RECOMMENDED SERVICE BULLETIN NO. RSB 40-08

Temporary Revision of the Flight Manual

TEMPORARY REVISION
TR-MÄM-40-069
Corrected Take-Off Chart

5.3.6 TAKE-OFF DISTANCE

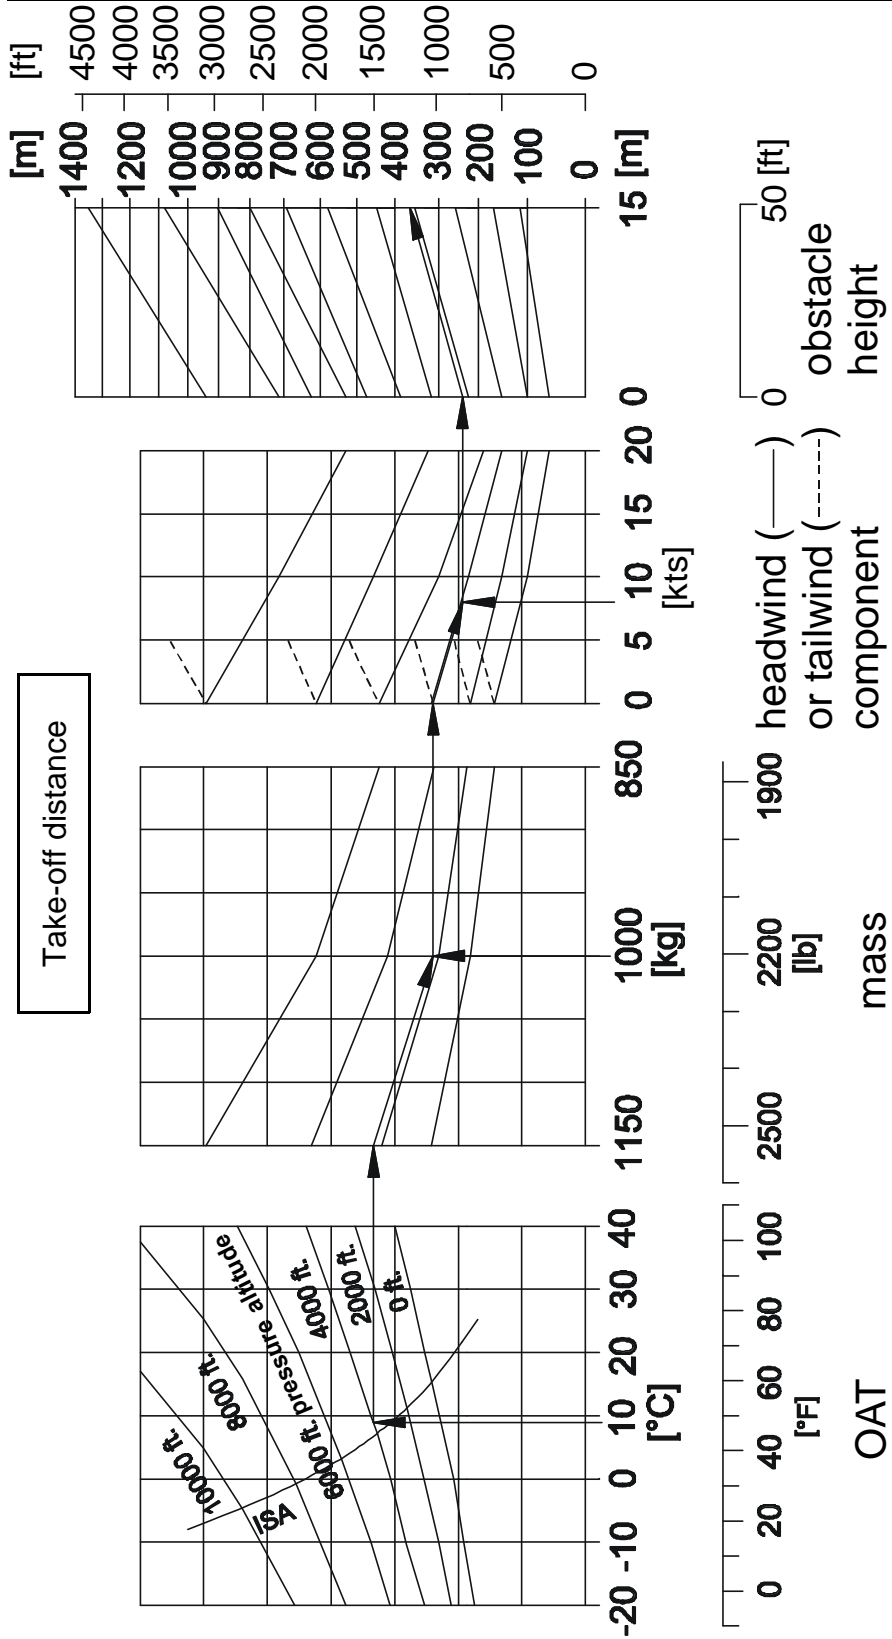
In the following graph, the take-off distances from metres to feet have been corrected due to a conversion error in publishing. Moreover, tailwind information has been added.

5.3.6 STARTSTRECKE

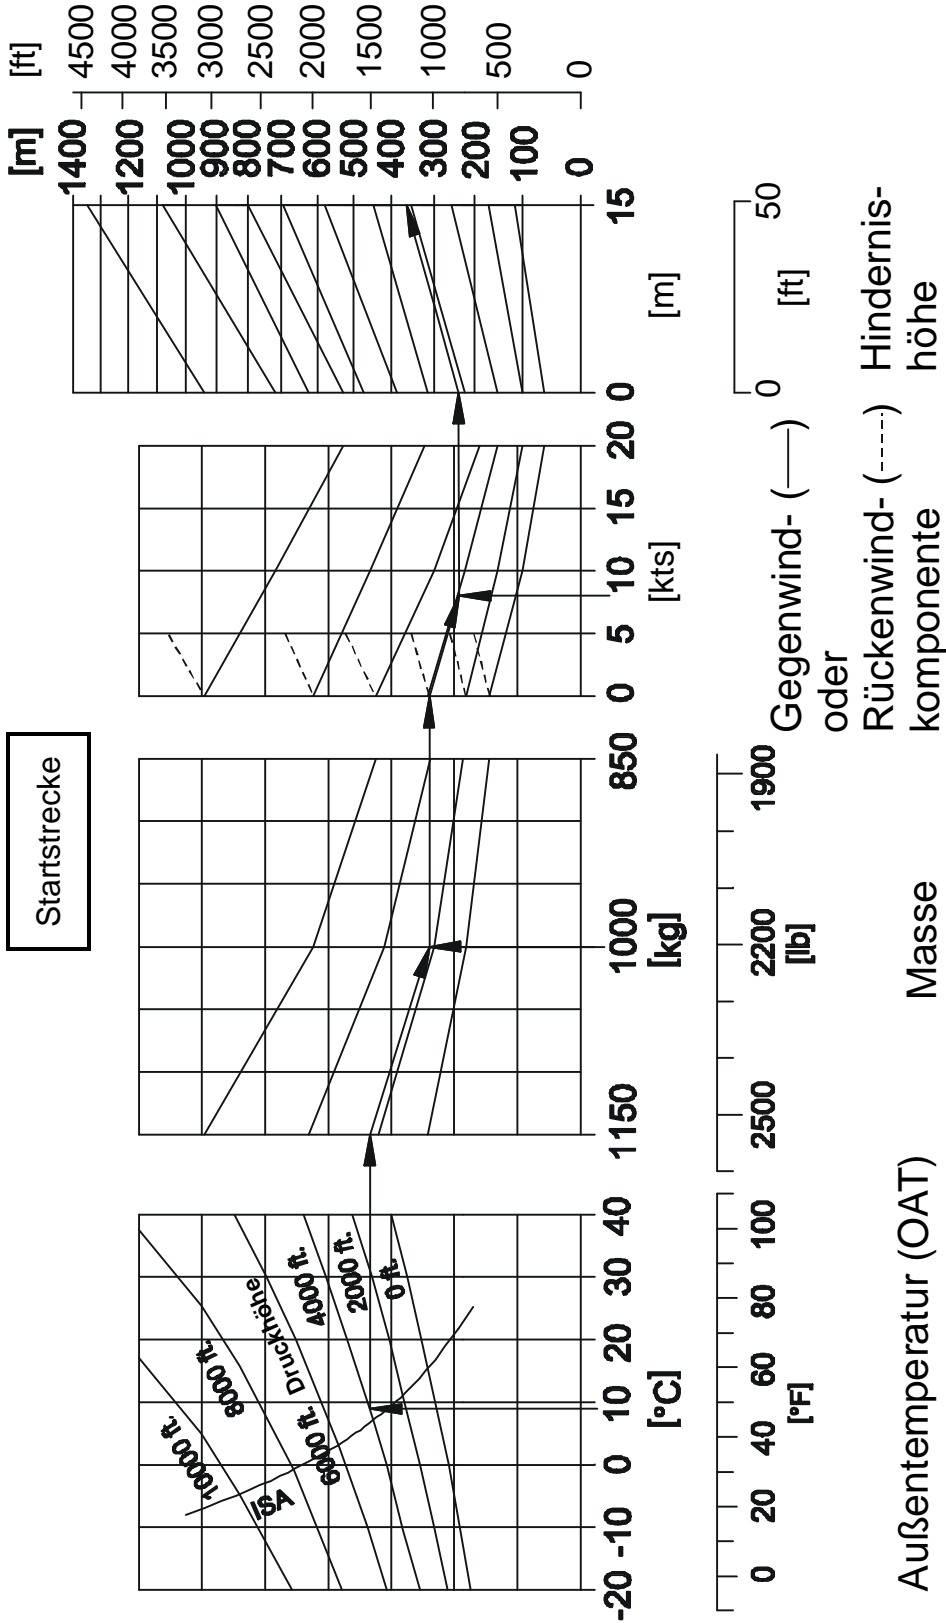
Im folgenden Diagramm wurde die Fuß-Skala für die Startstrecken korrigiert. Dies war aufgrund eines Umrechnungsfehlers notwendig. Darüberhinaus wurden Linien für Rückenwind hinzugefügt.
